Re: Former Chevron Service Station No. 30-7233
2259 First Street
Livermore, CA

Re: Revised Work Plan
Former Texaco Station #30-7233
2259 First Street
Livermore, California
Fuel Leak Case No. RO2908

RESPONSES TO TECHNICAL COMMENTS

Figure 2
SITE PLAN WITH PROPOSED MONITORING WELLS
FORMER TEXACO STATION (CHEVRON SITE 30-7233)
2259 FIRST STREET
Livermore, California

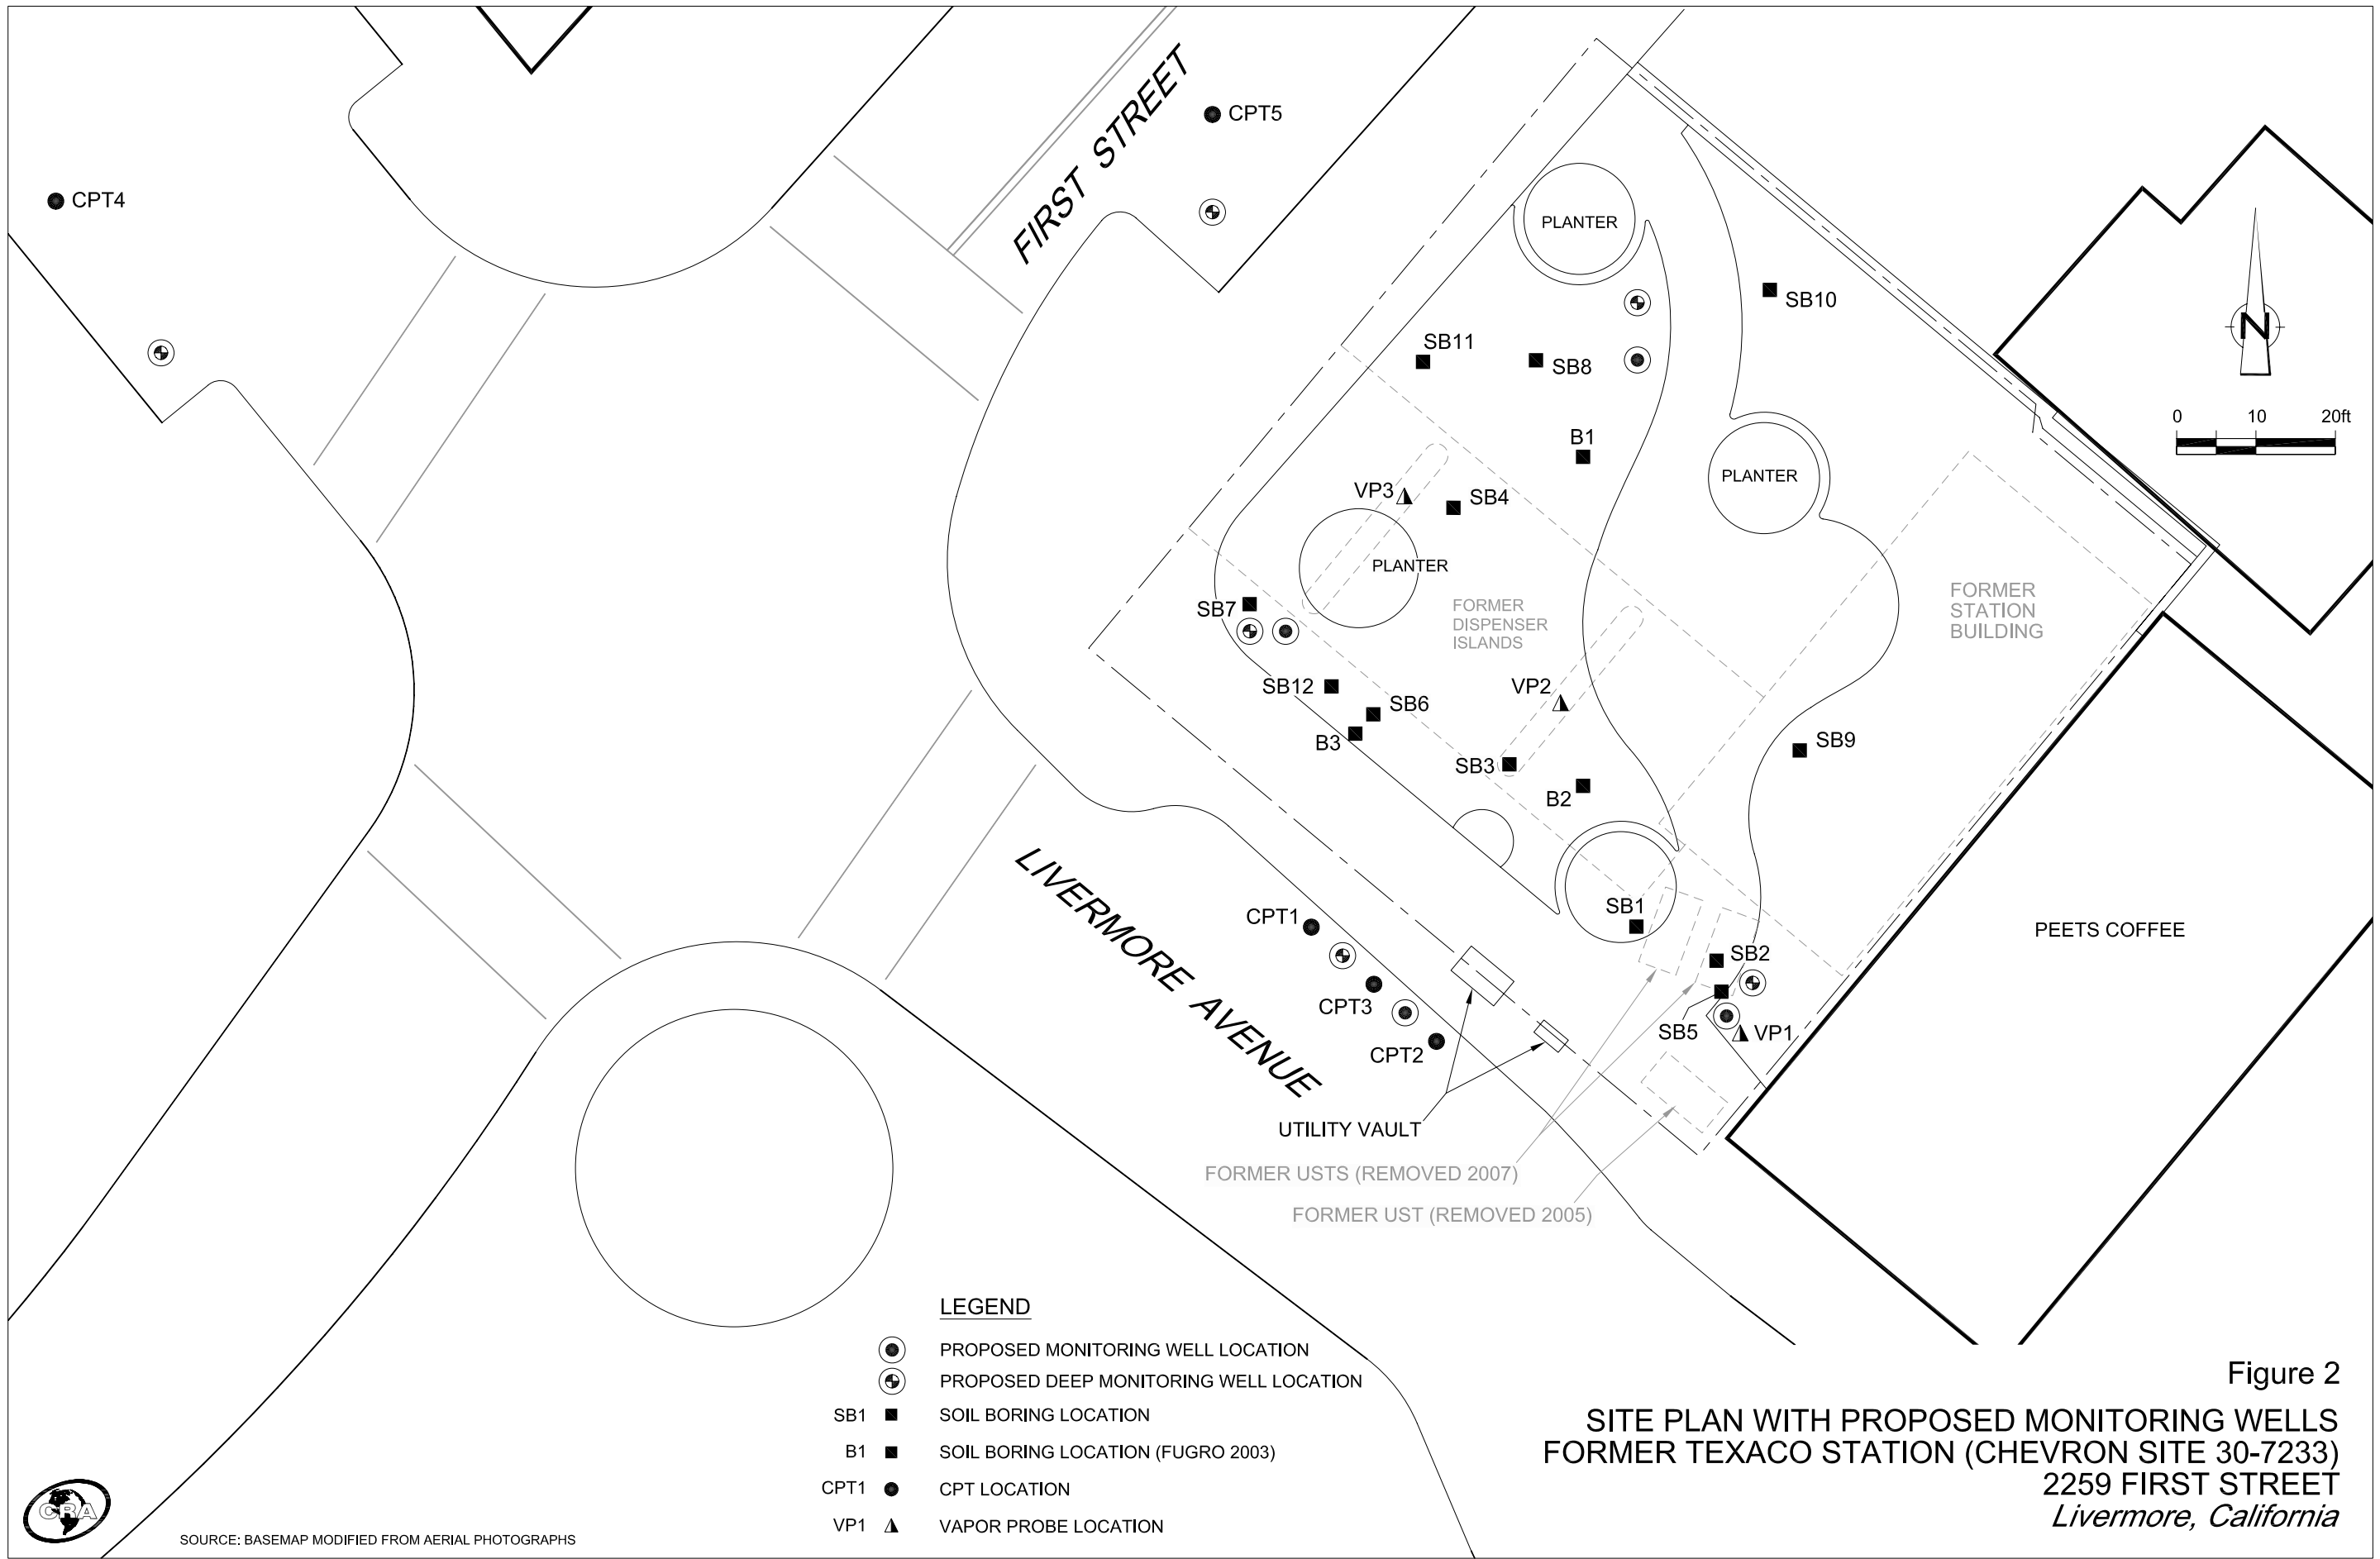
- 1 **Proposed Monitoring Well Locations** Three of the four proposed monitoring wells are located in a linear pattern that is perpendicular to the west northwest groundwater flow direction that occurs within the area of Livermore. The wells are apparently located adjacent to locations where groundwater contamination has been detected by previous sampling activities. Please give more consideration to the known sources and hydraulic gradient in proposing a groundwater monitoring network rather than targeting previous sampling locations. We request that you revise the proposed monitoring well locations in the Revised Work Plan requested below.

2. **Proposed Well Locations.** The Revised Work Plan maintains the four previously proposed locations and adds one location in a proximal cross gradient location to the former USTs. No wells are proposed downgradient of sampling locations CPT1 through CPT3 where TPHg was detected in groundwater at concentrations ranging from 10,000 to 47,000 micrograms per liter. In addition, three of the proposed monitoring wells are located in a linear pattern that is perpendicular to the west northwest groundwater flow direction that occurs within this area of Livermore. Although the proposed well configuration has limitations, the proposed fifth well may provide sufficient information to estimate the hydraulic gradient at the site. Therefore, we do not object to the proposed locations with the added caveat that additional downgradient delineation may be necessary contingent upon groundwater sampling results from the proposed wells.

CRA has moved and added well locations to comply with ACEH's request. We propose installing four clustered well pairs near borings SB5, SB7, SB8, and CPT1 (Figure 2). There is no evidence of a coarser grained shallow water-bearing zone above 54 feet below grade (fbg) in the cone penetration test (CPT) logs for borings CPT4 and CPT5. Therefore, we propose installing two deeper screened wells offsite adjacent to borings CPT4 and CPT5 (Figure 2). We have placed wells in locations that we believe the

City of Livermore will accept; however, the final locations may need to be adjusted dependant upon accessibility and permission from the City of Livermore. If the proposed well locations change significantly, we will notify ACEH prior to well installation.

Sounding CPT-01

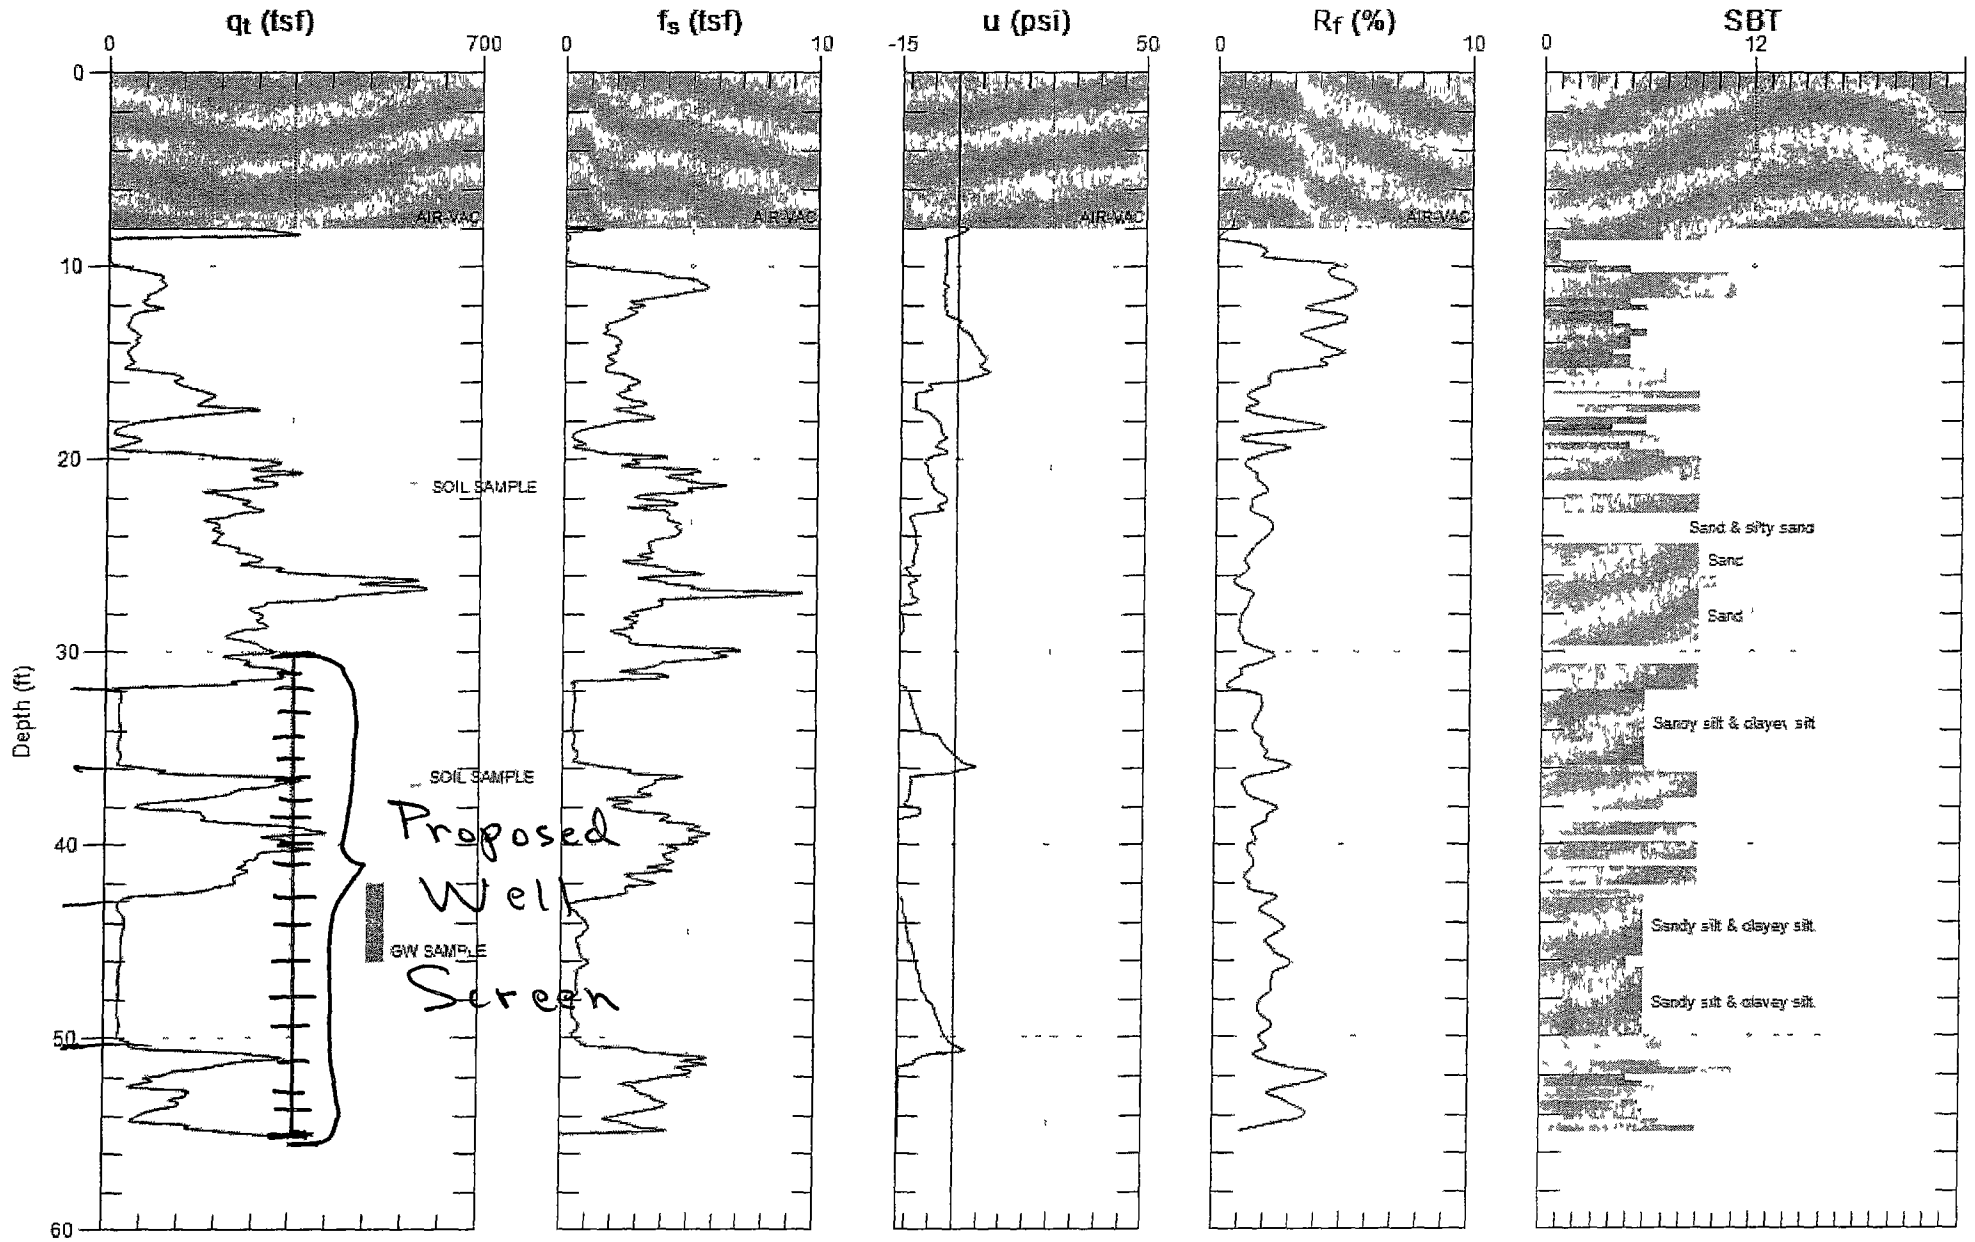
- 2 **Proposed Well Screen Intervals** The proposed screen intervals for the four monitoring wells are 30 to 55 feet bgs based on previous depth to first encountered water and variable groundwater elevations at nearby sites. Site hydrogeologic conditions than variable depths to first encountered groundwater must be considered in designing well screen intervals. The well screen intervals must target discrete water bearing layers and not create vertical conduits for ambient well flow. Where necessary, multiple wells must be installed to monitor separate vertical intervals. Since the proposed well locations are adjacent to previous soil borings, the hydrogeologic conditions at the proposed locations are known and must be considered. As one example, we have attached the CPT log for boring CPT-1, which is adjacent to one of the proposed well locations. As shown on Attachment 1, the proposed well screen interval from 30 to 55 feet bgs connects three separate coarse-grained layers that are separated by finer grained layers. A well constructed in this manner at the proposed location would provide a conduit for vertical flow and water levels in the well would be affected by vertical gradients between the difference intervals. Clearly, the proposed well screen interval for a well adjacent to CPT-1 would not be appropriate. A second example of the need to consider the site hydrogeology is shown on Attachment 2, which is the CPT log for boring CPT-5. The proposed well adjacent to CPT-5 would be screened exclusively in the finer-grained soils consisting of silts and clays present between approximately 11 and 55 feet bgs. The proposed well screen would not intersect any permeable water-bearing layers. Therefore, the proposed well at this location would not provide sufficient data on contaminant migration off-site since the well does not intersect the likely pathway for contaminant migration. Please review site hydrogeology and propose screen intervals that are appropriate for the site.

Deeper Well Screen Interval: CRA proposes installing six deeper monitoring wells at the site (Figure 2). Coarser grained sediments and groundwater have been consistently observed throughout the site at approximately 54 fbg; therefore we propose installing a 5-foot screen interval between 54 and 59 fbg. The final screen interval will be based on field observations at the time of installation. Wells will be installed as described in our September 28, 2009 *Revised Work Plan*. We will install the deeper wells first to determine where shallow monitoring wells should be installed and how they should be screened.
